2026

**TECHNICAL COMMITTEE MEETING  
MONOGRAPH**

**2026 Water Efficiency and Sanitation Standard  
Technical Committee Meeting  
IAPMO World Headquarters, Ontario, CA  
May 13 – 14, 2026**

**FIGURE F 301.1(6)**  
**GRAY WATER DRAINAGE SYSTEM – CLOTHES WASHER GRAYWATER SYSTEM WHERE GRAYWATER IRRIGATION PIPE IS RUN THROUGH CRAWLSPACE\***

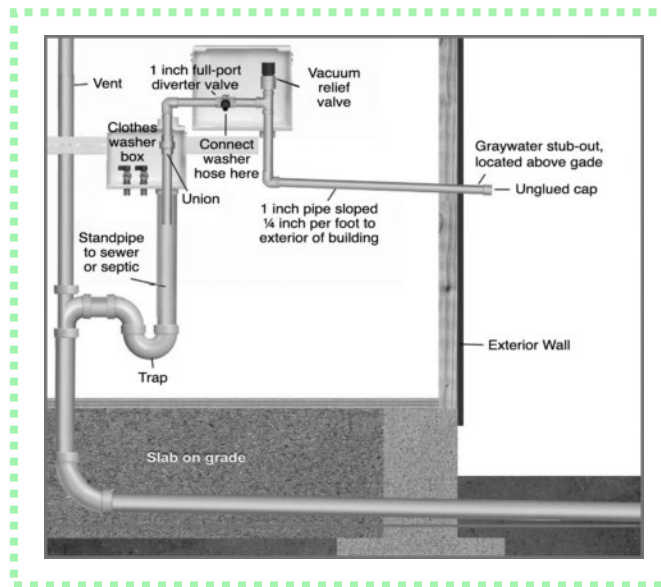
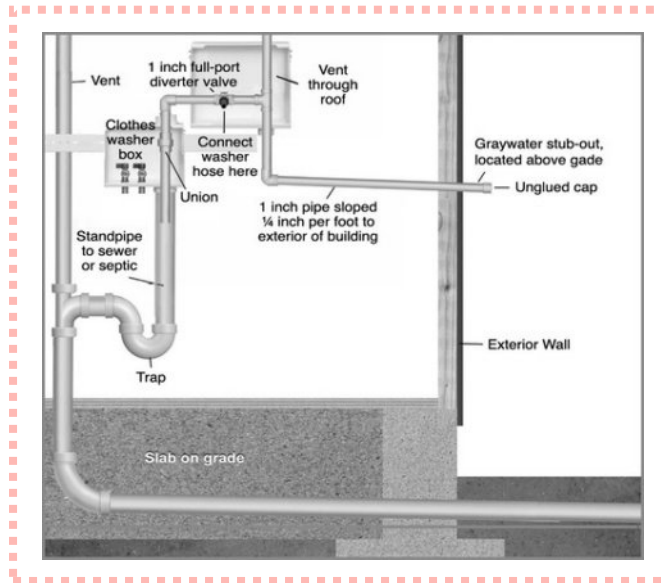
**Section Number:**  
Figure F 301.1(6), Figure F 301.1(7)

**SUBMITTER:**  
Pat Lando

FIGURE F 301.1(6)

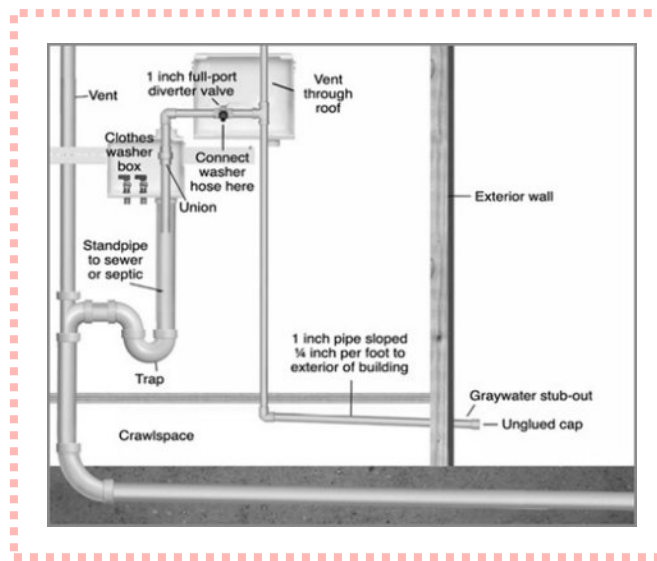
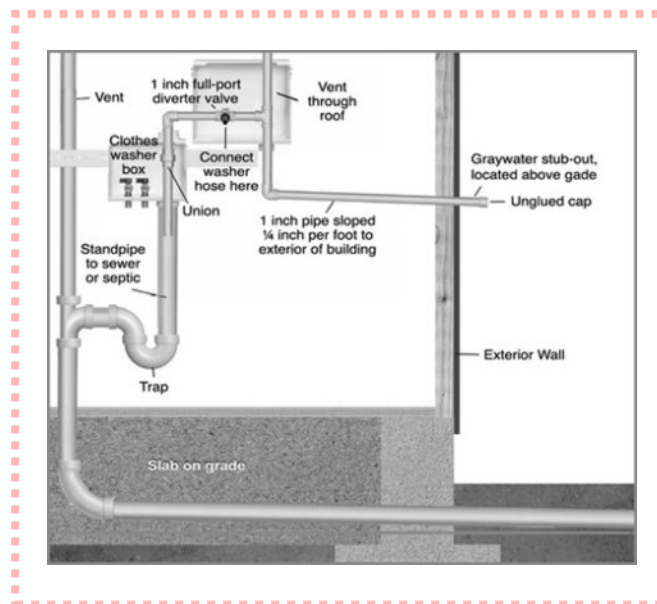
**Exception:** Gray water drainage piping coming directly from a clothes washer. ~~[See Figure F 301.1(6) and Figure F 301.1(7).]~~

**Exception:** Gray water drainage piping from a clothes washer system that diverts directly from the appliance. ~~[See Figure F 301.1(6) and Figure F 301.1(7).]~~

Based on the continuing confusion regarding the intent of Figure F 301.1(6) and Figure F 301.1(7), the Gray Water Systems Task Group is proposing an alternative recommendation to strike these two figures and their corresponding references within Appendix F.
